Submissions and Preferred Infrastructure Report

Newcastle Inner City Bypass
Rankin Park to Jesmond

Newcastle Inner City Bypass – Rankin Park to Jesmond Submissions and preferred infrastructure report

Roads and Maritime, as the proponent of the project, has prepared this submissions and preferred infrastructure report to respond to issues raised in submissions and describe and assess design refinements made since the exhibition of the EIS.

Figure 5-5
Southern interchange – pedestrian and cyclist facilities

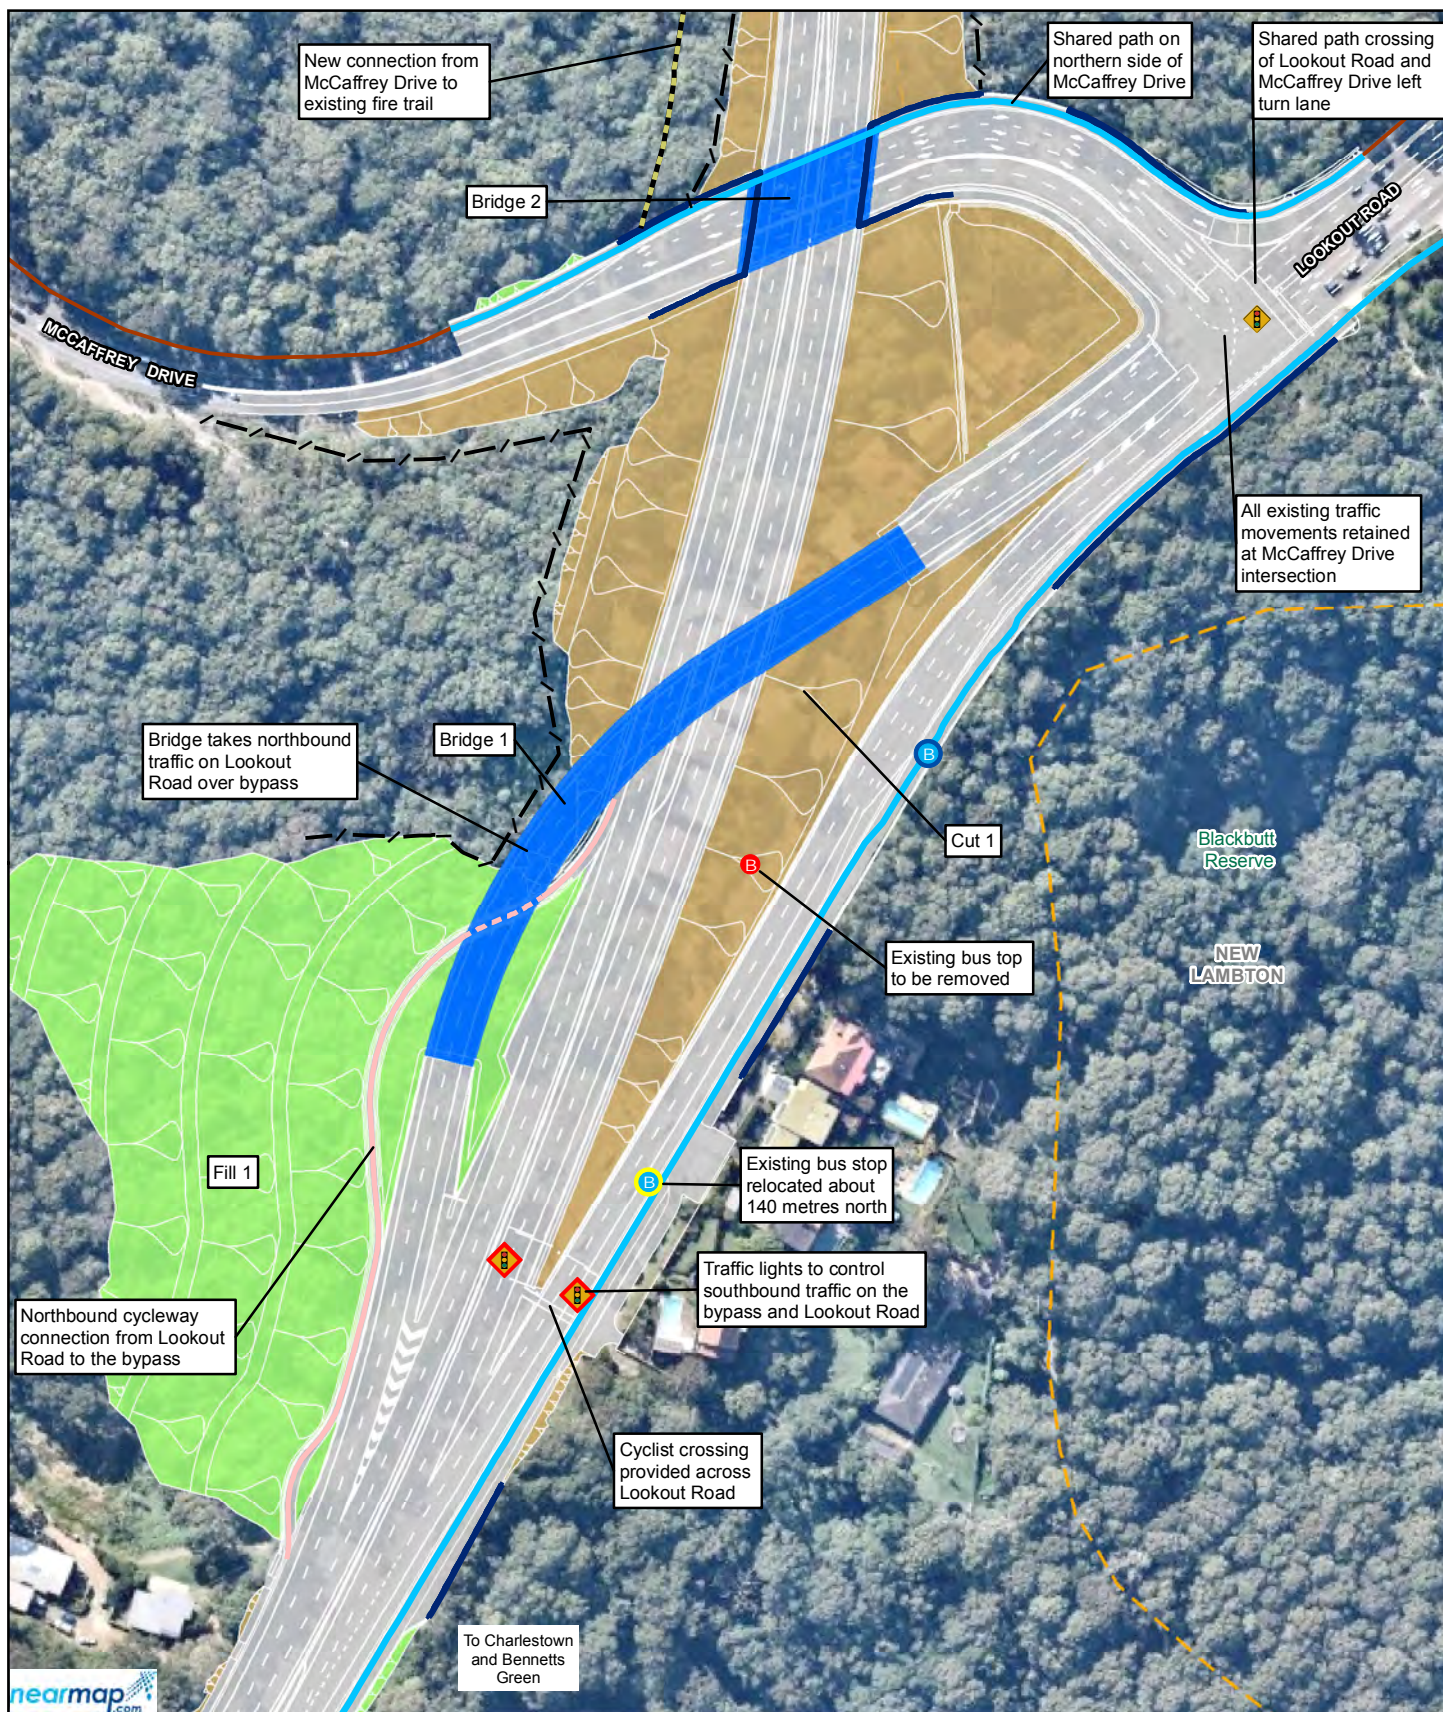
The project would now provide a new northbound cycleway connection (one way only) as shown in Figure 5-5. This enables northbound on-road cyclists to exit Lookout Road and pass beneath the flyover before re-joining the northbound road shoulder of the bypass.

The existing footpath would now be replaced with a three metre wide shared path for use by both pedestrians and cyclists as shown in Figure 5-5. The shared path would be three metres wide and would connect with existing footpaths on Lookout Road and McCaffrey Drive.

The existing pedestrian only crossing point on the northern side of the Lookout Road and McCaffrey Drive intersection would now be replaced with a shared path crossing for use by both pedestrians and cyclists as shown in Figure 5-5. The existing crossing of the left turn lane from McCaffrey Drive onto Lookout Road, would also now be a shared path crossing controlled by traffic lights.

Figure 5-6 Typical operational water quality treatment structure

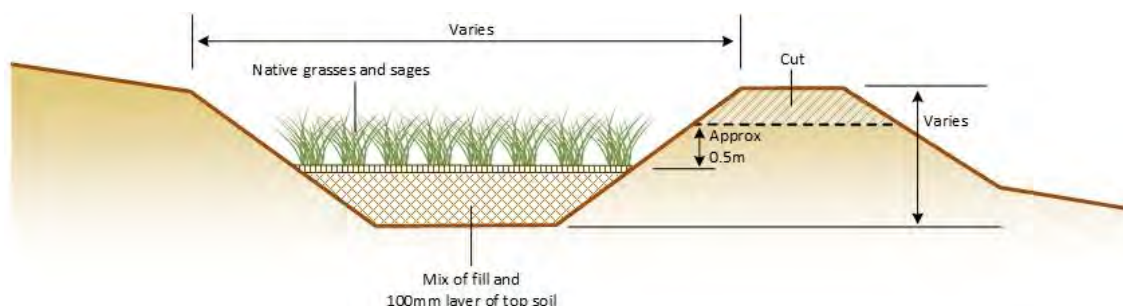
A typical layout for these operational water quality treatment structures is provided in Figure 5-6.

Figure 5-8a
Construction ancillary facilities

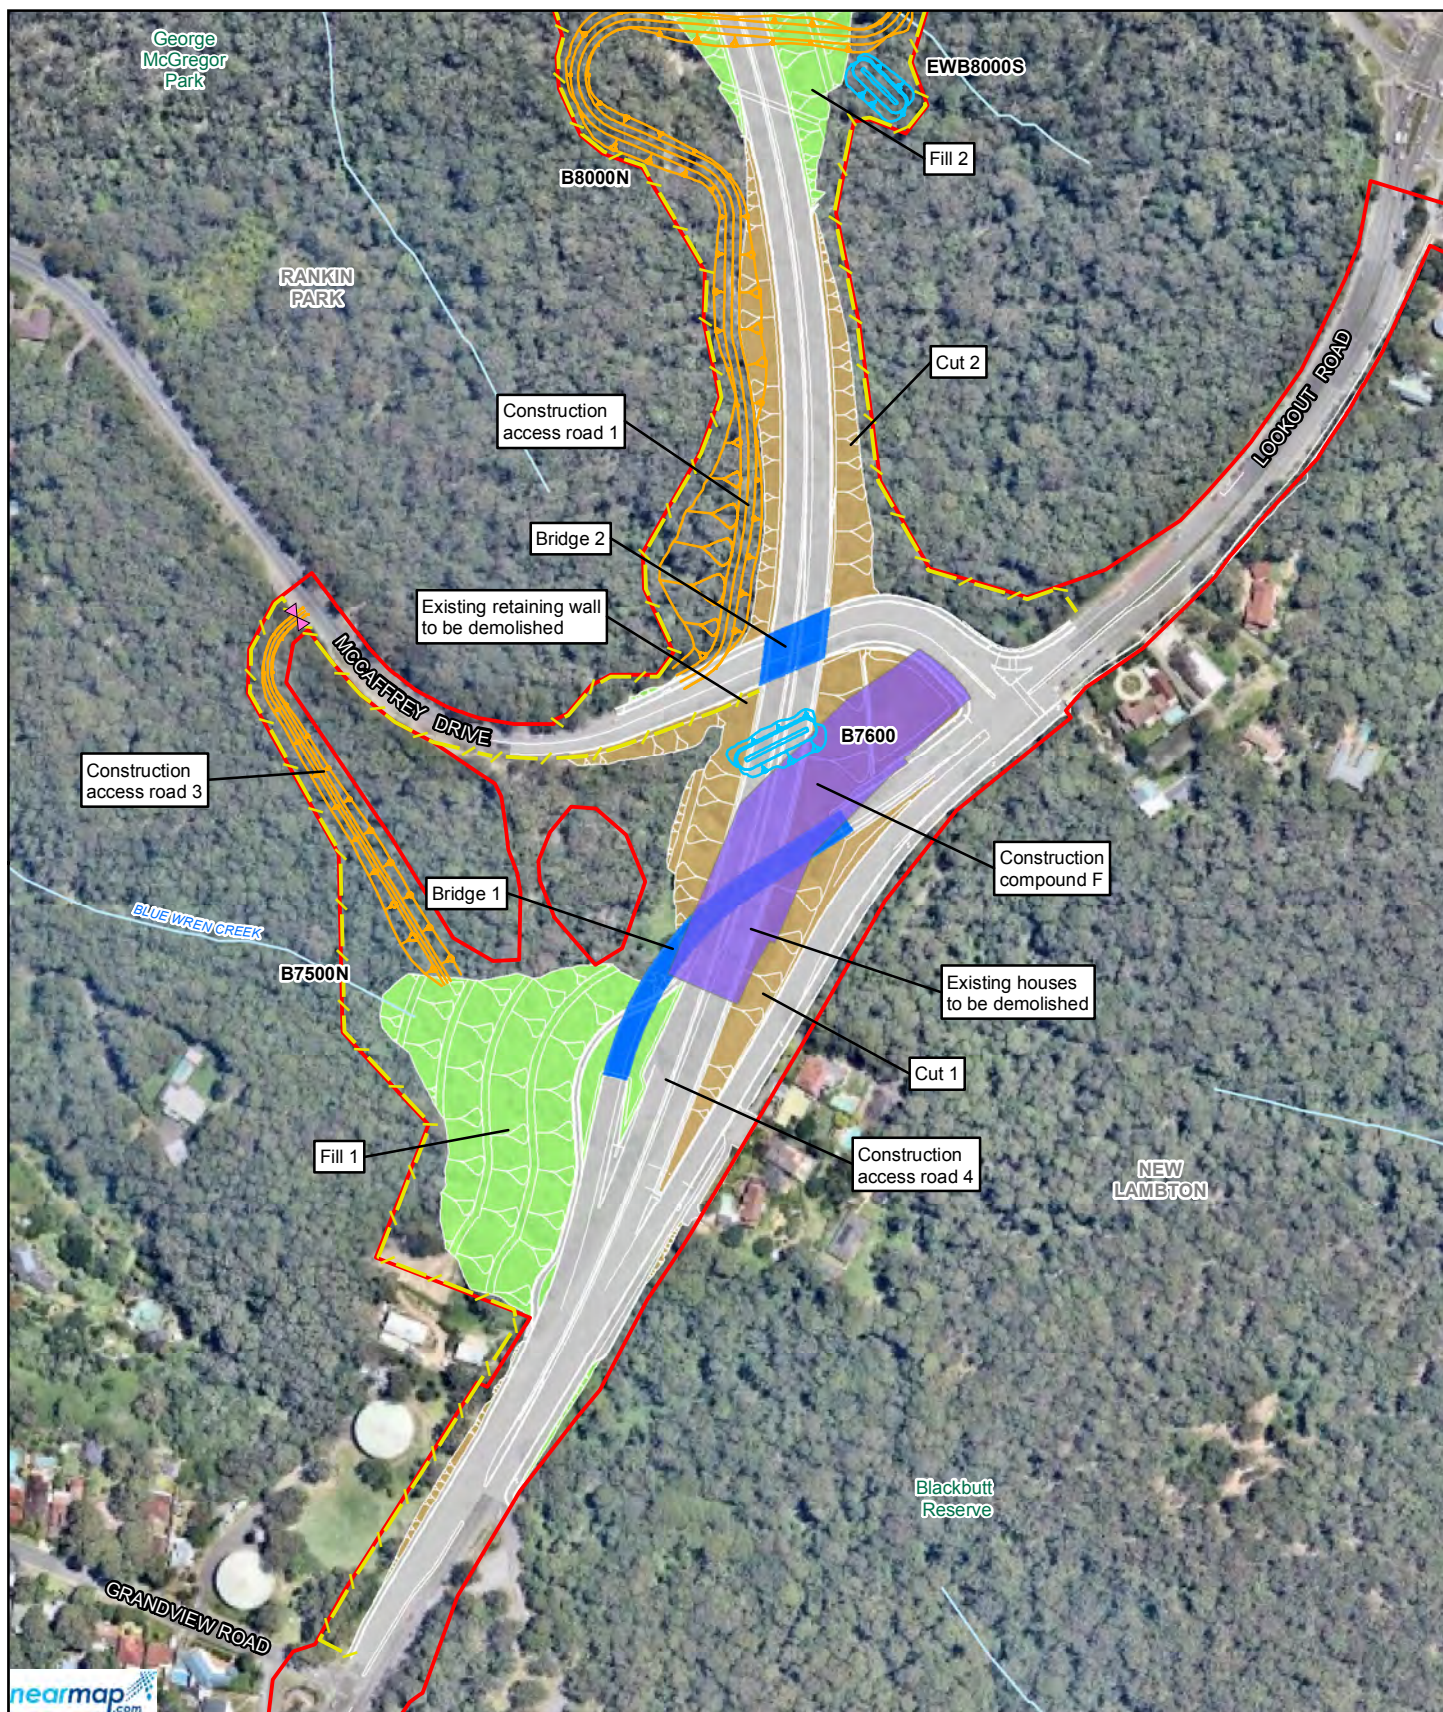
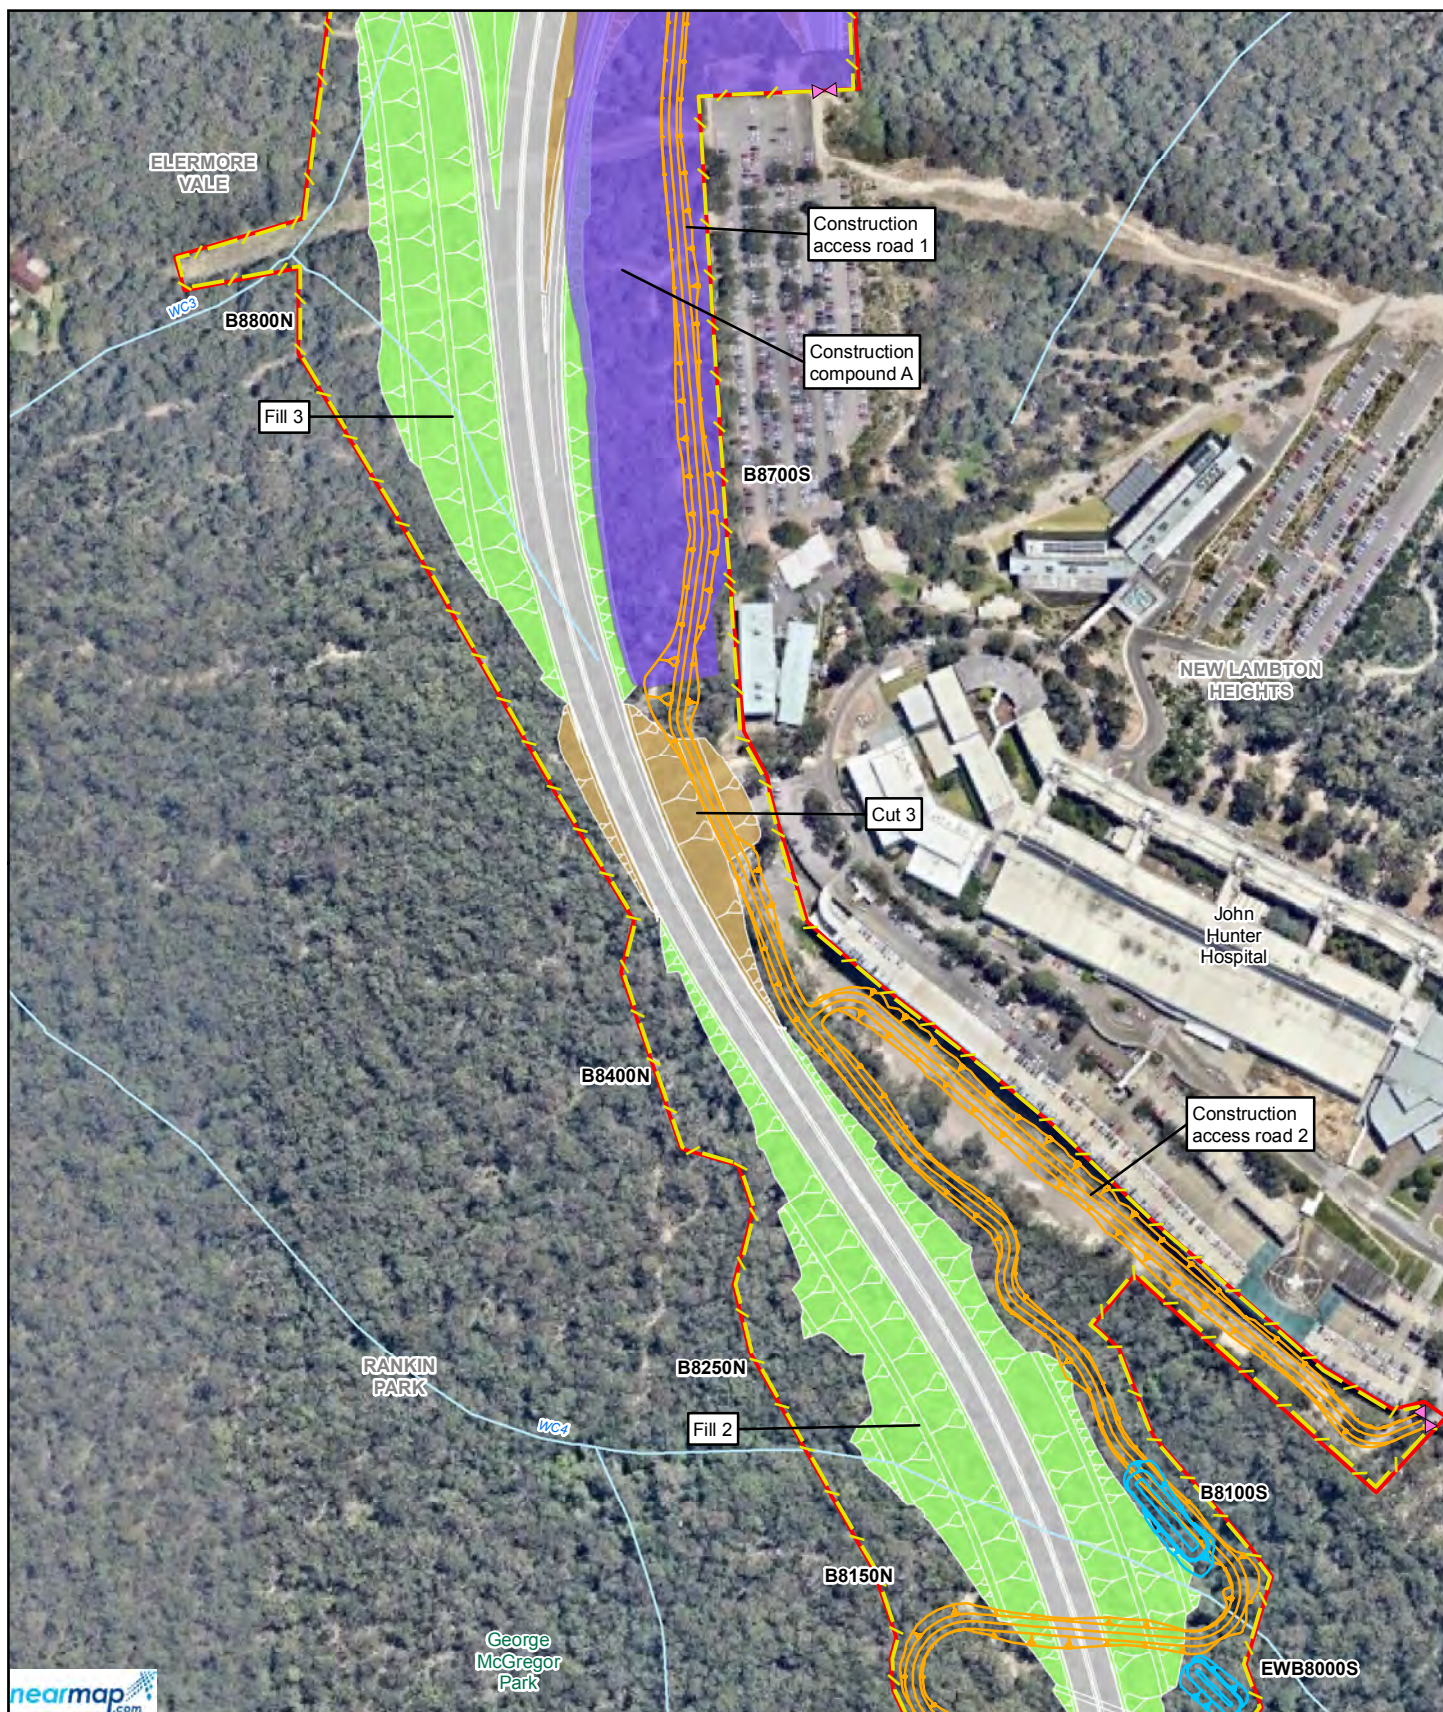
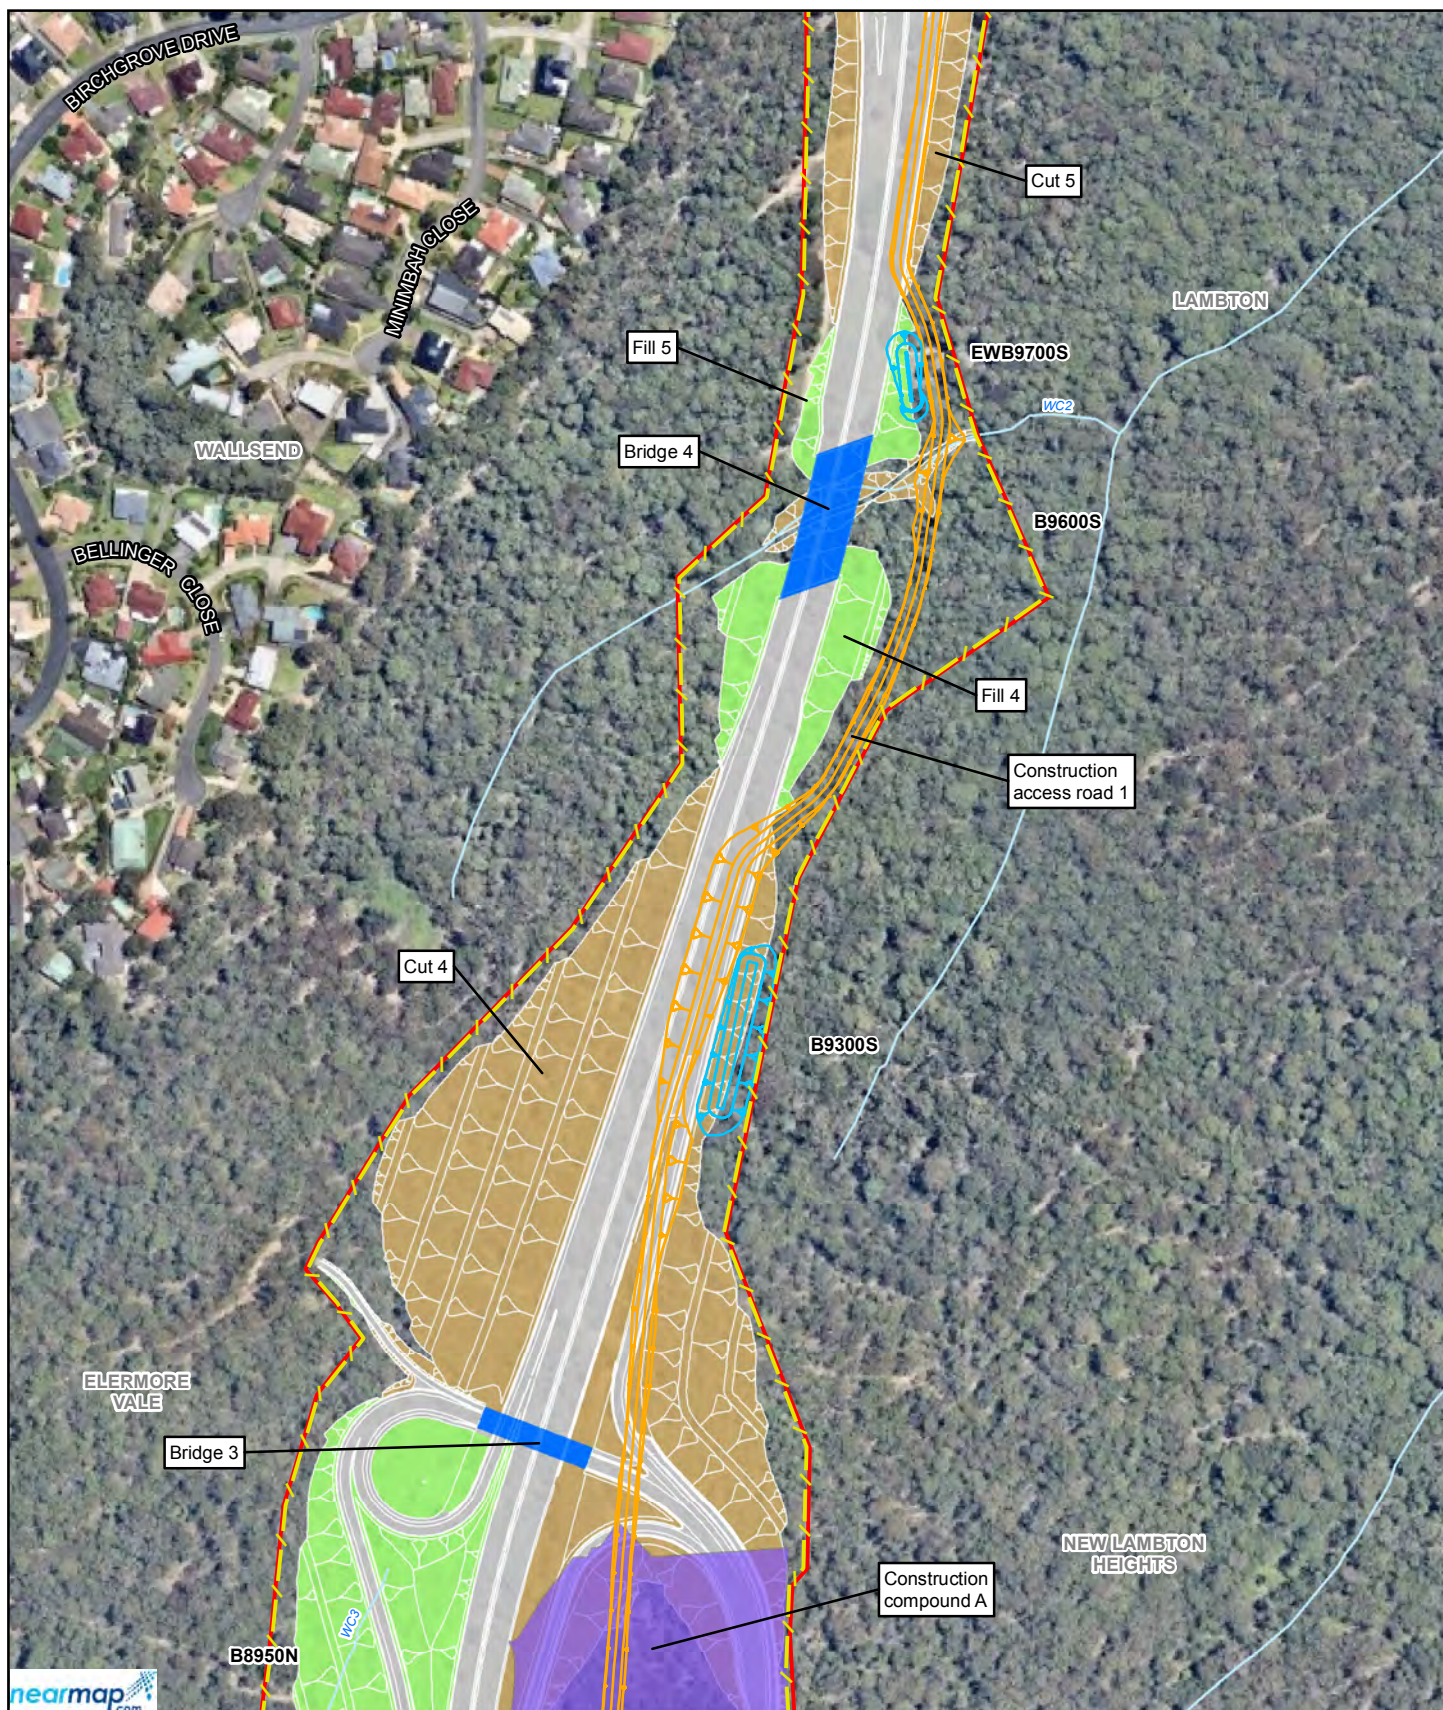
The locations of the construction compounds are shown in Figure 5-8 and a description is provided in the following sections. They have been located based on:

Compound B is about 1.3 hectares (increased by about 0.05 hectares) (it is noted there was a typographical error in the EIS which stated the area was 1.5 hectares) in area and is located next to the northern interchange (Figure 5-8). Access to this construction compound would be via a temporary access arrangement from or near the existing Jesmond roundabout.

Compound C is about 1.7 hectares in area (increased by about 0.06 hectares) and is located next to the northern interchange (Figure 5-8). Access to this construction compound would be via a temporary access arrangement from or near the existing Jesmond roundabout.

Compound D (new compound) is about 0.2 hectares in area and is located near the eastern end of Jesmond Park on the southern side of Newcastle Road (Figure 5-8). Access to this construction compound would be via Robinson Avenue and/or temporary access arrangement from Newcastle Road.

Compound E (new compound) is about 0.1 hectares in area and is located near the intersection of Coles Street and Steel Street on the northern side of Newcastle Road (Figure 5-8). Access to this construction compound would be via Steel Street, Coles Street and/or temporary access arrangement from Newcastle Road.

Compound F (new compound) is about 0.9 hectares in area and is located near the southern interchange on the western side of Lookout Road (Figure 5-8). Access to this construction compound would be via Lookout Road and/or McCaffrey Drive.

Due to other design refinements, during construction there will be still be about 16 sedimentation basins but some would be in new locations to capture sediment laden runoff from construction areas (Figure 5-8).
